RAI 03.07.02-24, Supplement 1, Revision 1**QUESTION:****Follow-up Question to RAI 03.07.02-15 (STP-NRC-100036)**

UHS Basin and RSW Pump House:

RSW Piping Tunnel:

**Figure 3H.6-241: At-Rest Lateral Earth Pressure on the Diesel Generator Fuel Oil Storage
Vault Walls**

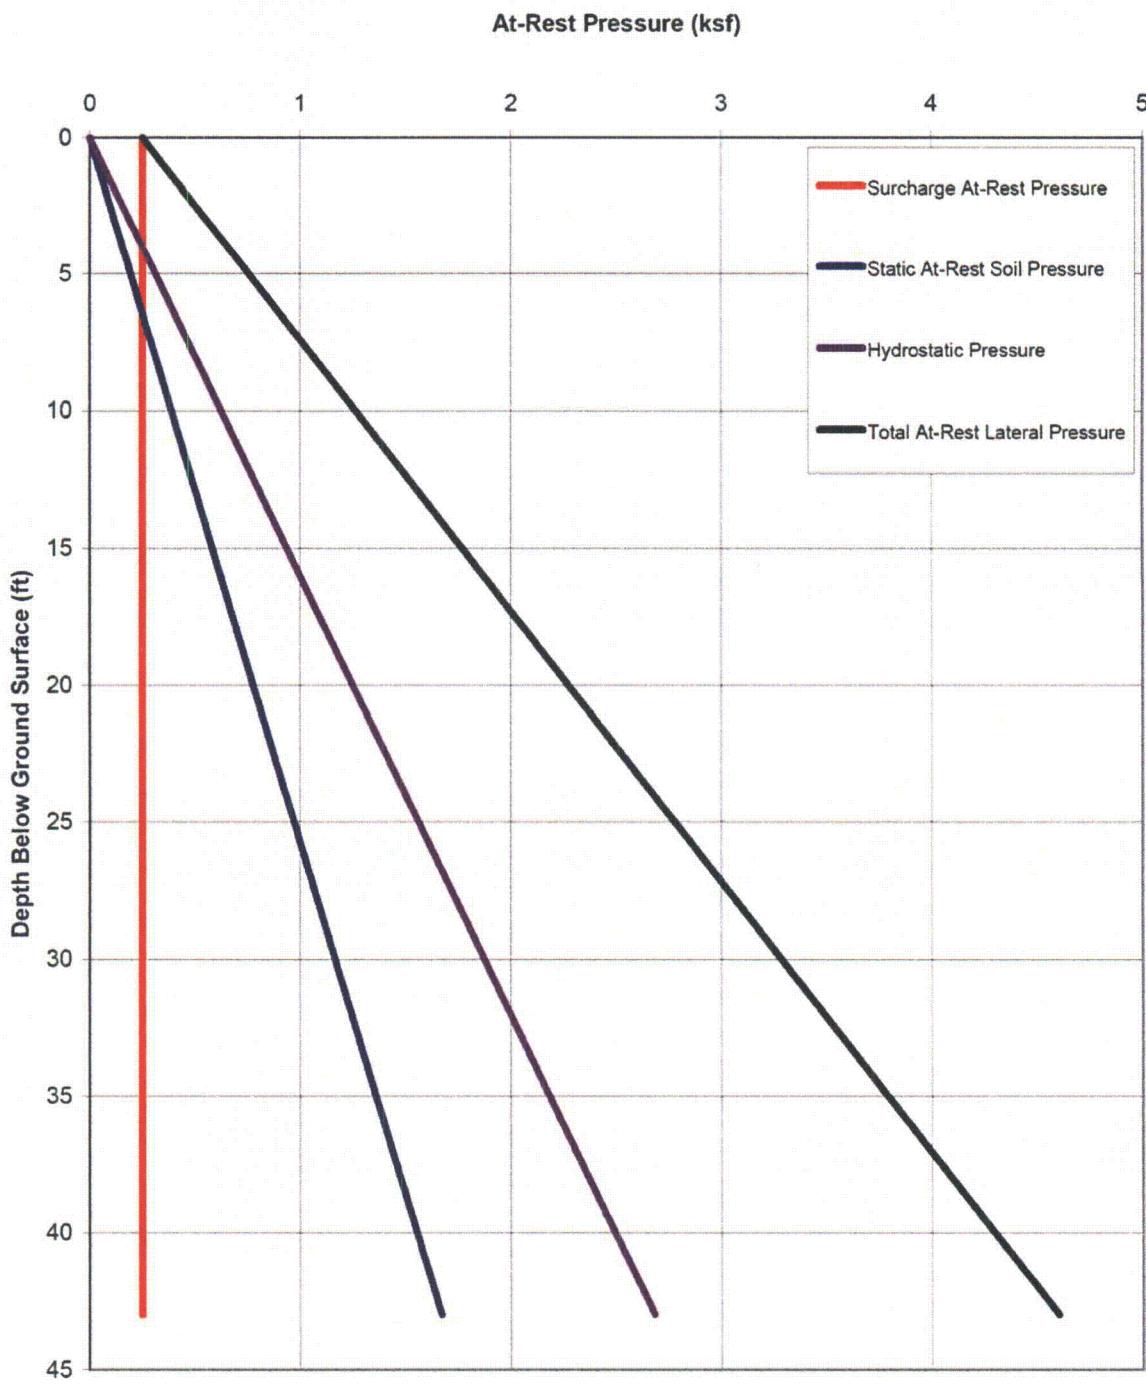
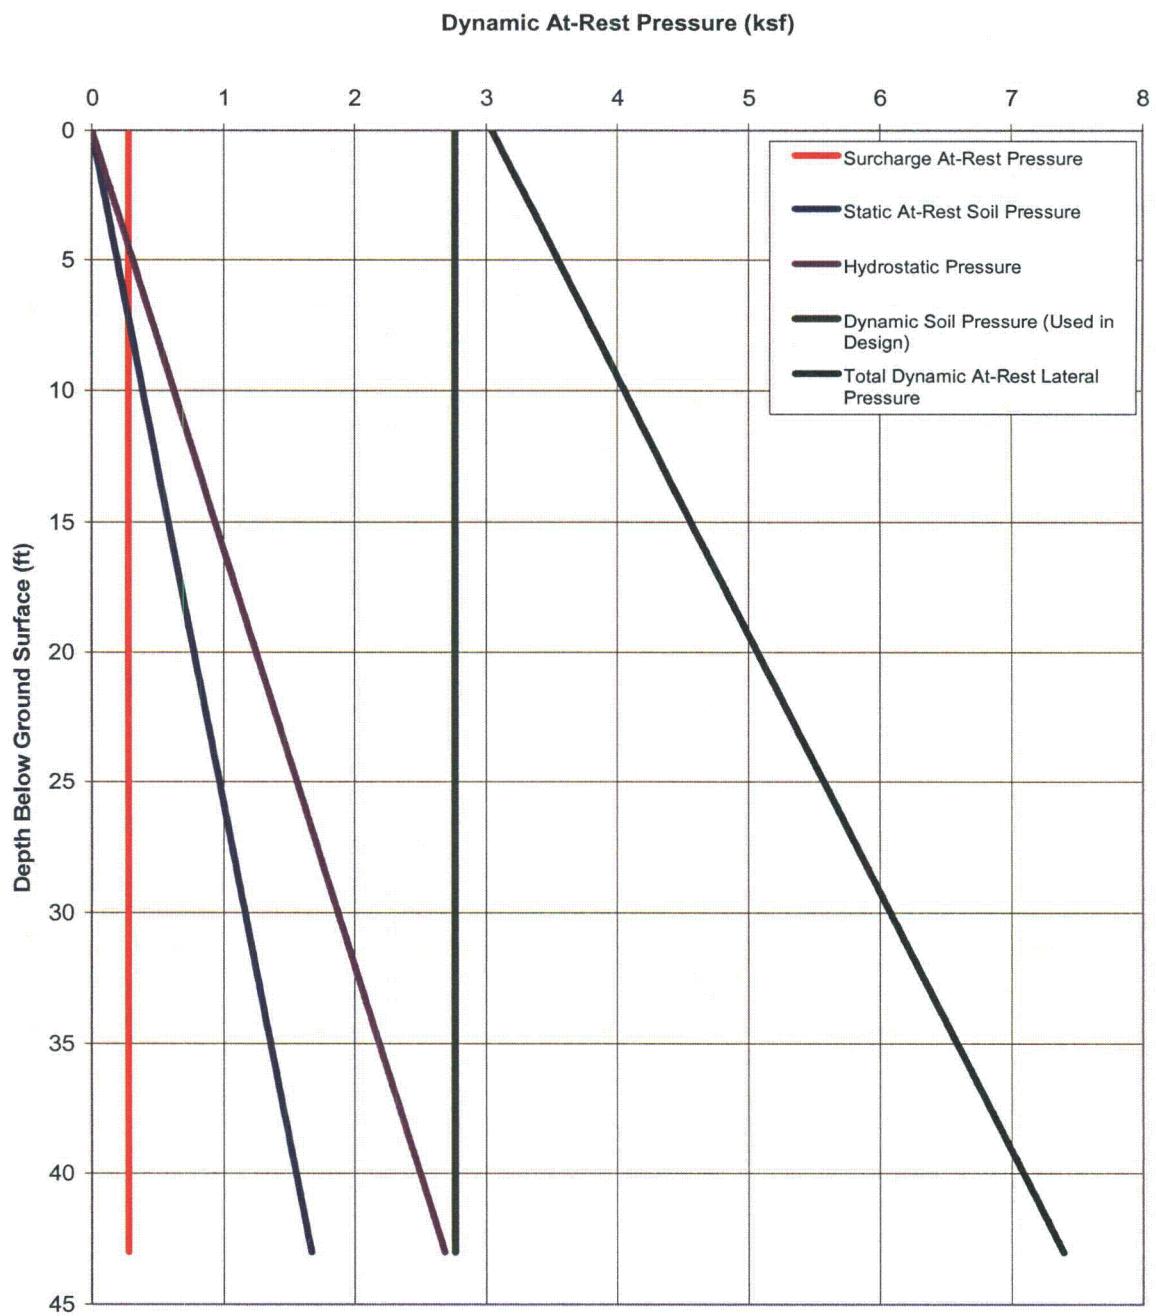
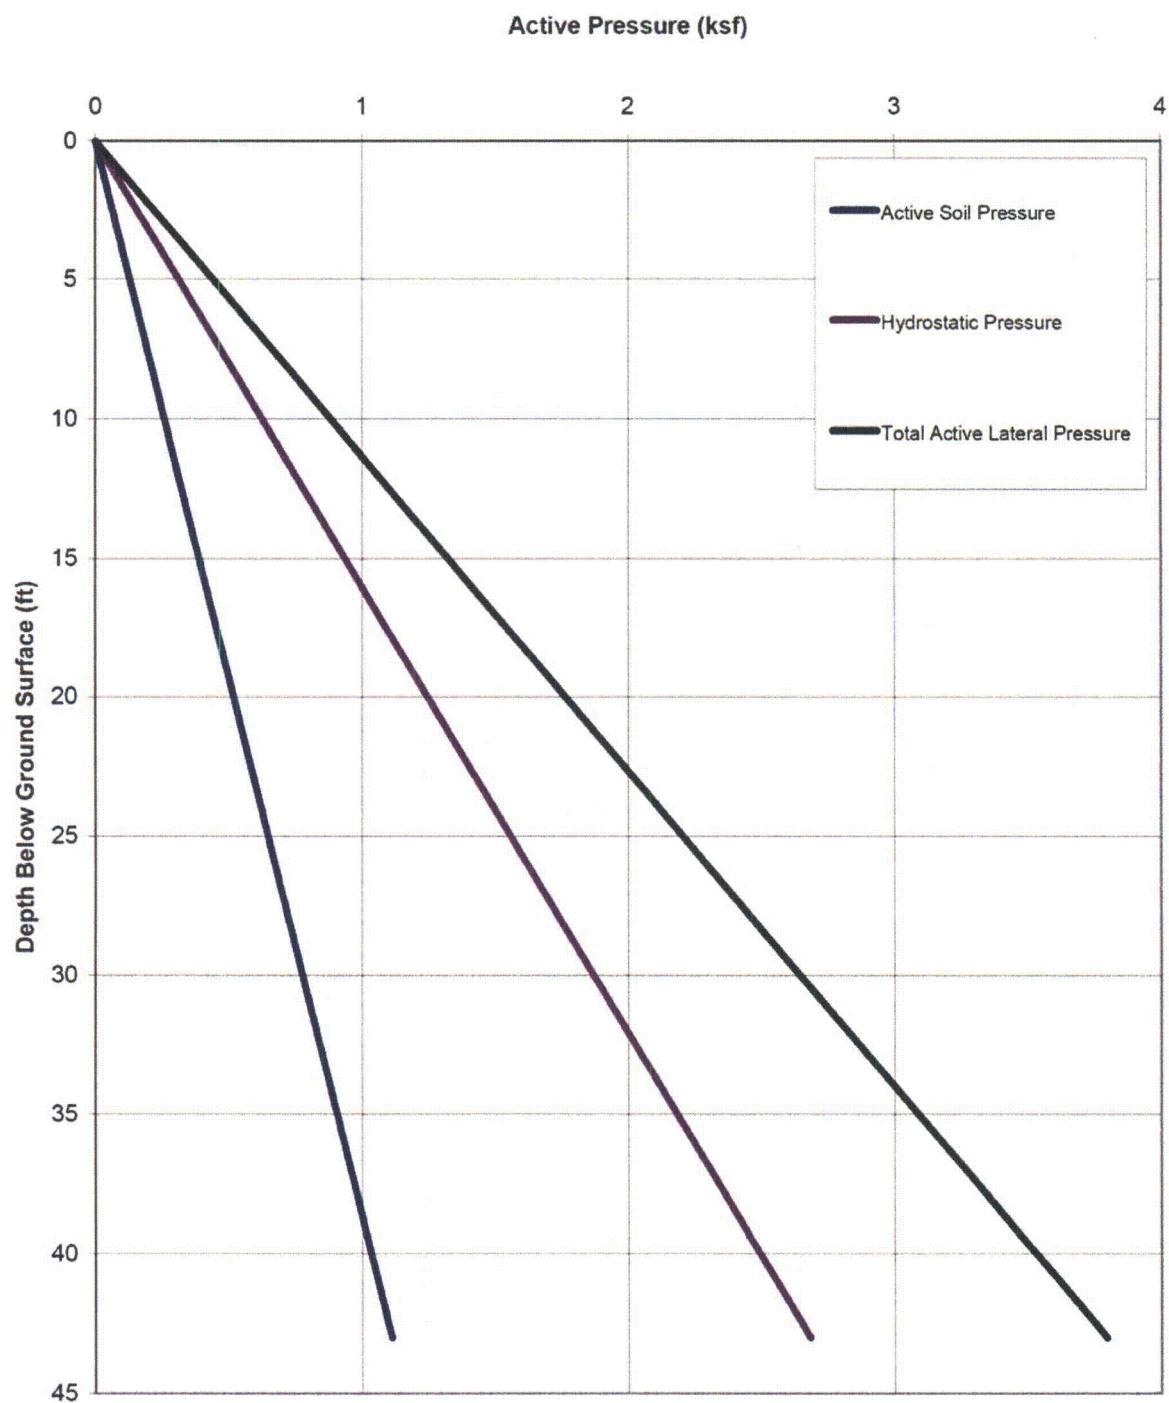
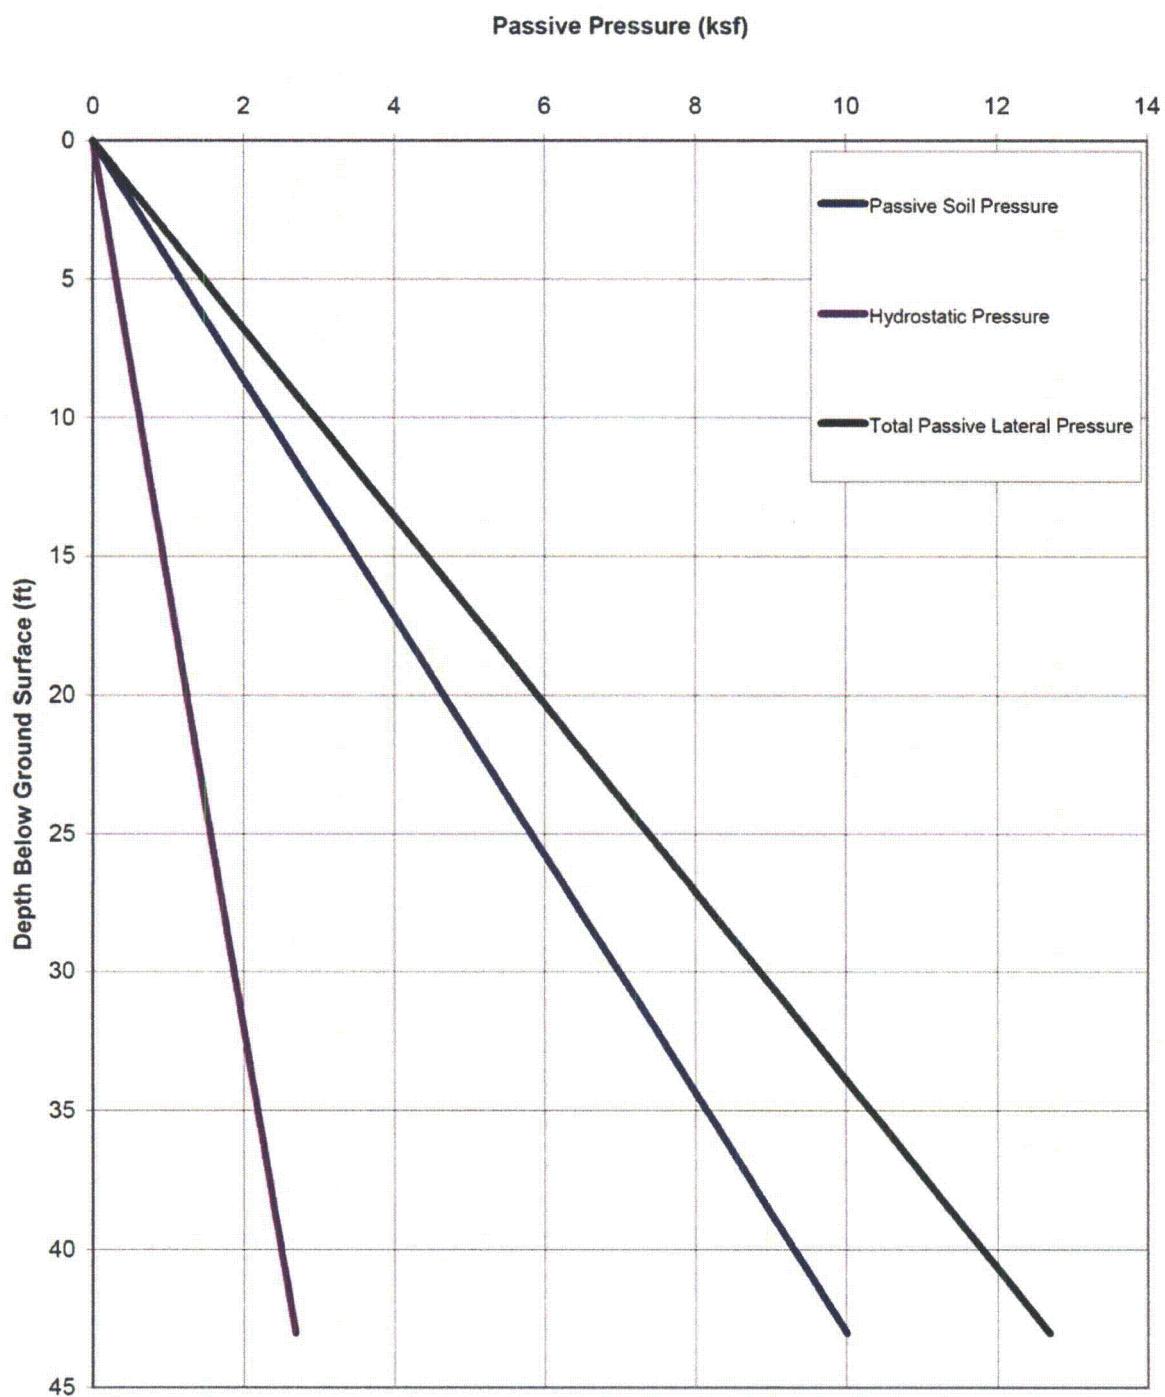
- b) For the staff to conclude that the design of structures with deep foundations, such as the Reactor Building (RB) and Control Building (CB), is satisfactory for the site, the site-specific design loads are needed to compare with the design loads used for the DCD. Lateral soil pressure is one such load. Therefore, please provide the lateral soil pressures for the RB and the CB, and compare these calculated pressures with those used in the ABWR standard plant design. Please also confirm if the effects of adjacent structures are considered in computing the lateral soil pressures, and if not, provide the justification for not doing so.

The structure-soil-structure interaction (SSSI) incremental seismic soil pressure curves for the Diesel Generator Fuel Oil Storage Vault (DGFOSV) have been provided in COLA Part 2, Tier 2, Figures 3H.6-226 through 3H.6-231, in the response to RAI 03.07.01-27, Supplement 1, Revision 1, which is being submitted concurrently with this response. The at-rest, dynamic at-rest, active, and passive soil pressure profiles are provided in Figures 3H.6-241 through 3H.6-244, included in Enclosure 1 of this response.
